UNITED STATES PATENT AND TRADEMARK OFFICE

APPLICATION NO.	FILING DATE	FIRST NAMED INVENTOR	ATTORNEY DOCKET NO.	CONFIRMATION NO.
10/694,054	10/28/2003	Keiichi Kunimoto	740737-282	3885
22204	7590	07/24/2006	EXAMINER CHAMBERS, TROY	
NIXON PEABODY, LLP 401 9TH STREET, NW SUITE 900 WASHINGTON, DC 20004-2128			ART UNIT 3641	PAPER NUMBER

Office Action Summary	Application No.	Applicant(s)	
	10/694,054	KUNIMOTO, KEIICHI	
	Examiner	Art Unit	
	Troy Chambers	3641

FIG. 1

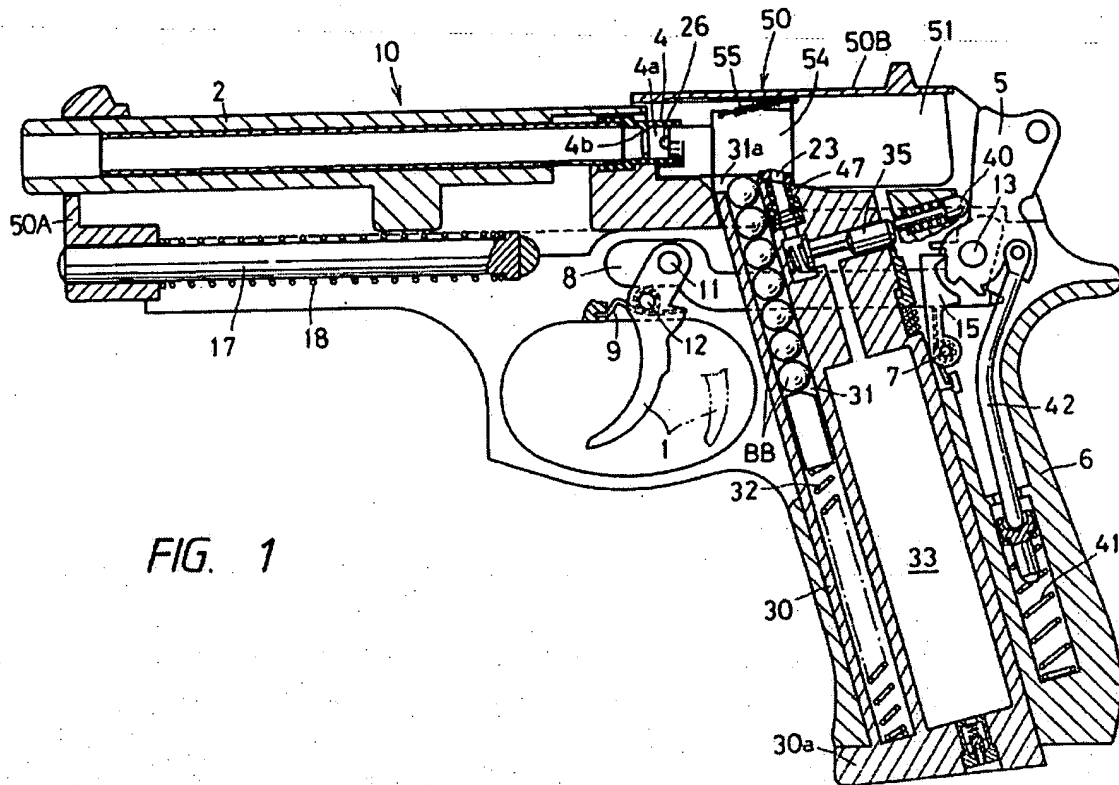
2. Claims 1-3, 5 and 6 are rejected under 35 U.S.C. 102(b) as being anticipated by US 5476087 issued to Kunimoto.

3. With respect to claim 1, Kunimoto discloses a toy gun comprising:

| a. | a frame | 10 |
| i. | barrel | 02 |
| ii. | loading chamber | 4a |
| iii. | trigger | 01; |
| b. | a movable member | 51 |
| iv. | pressure receiving portion | 51A |
| c. | driving mechanism | 05 |
| d. | gas supply controller | 35, 36, 37, 40 |
| e. | a gas passage forming member | 54 |
| v. | 1 st gas passage | 21 |

- vi. 2nd gas passage 51B
- f. movable valve 27
- vii. valve operation col. 9, l. 62 to col. 10, l. 46.

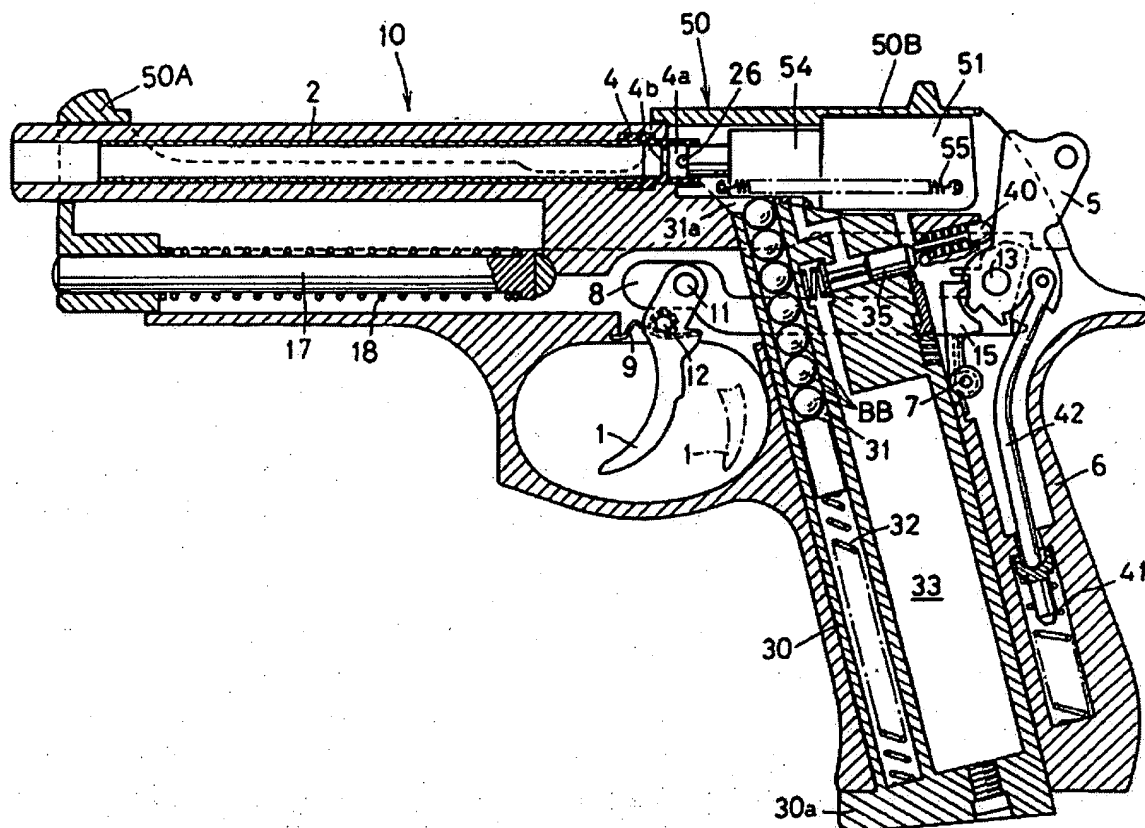
5. With respect to claim 3, the device as disclosed by Kunimoto inherently performs the claimed functions.

6. With respect to claims 5 and 6, Kunimoto discloses:

- g. a gas/accumulation chamber 33
- h. control valve 35.

7. Claims 1-3, 5 and 6 are rejected under 35 U.S.C. 102(b) as being anticipated by US 5477843 issued to Kunimoto. The '843 has the same or similar relevant structure similar to that of the '087 patent as shown below.
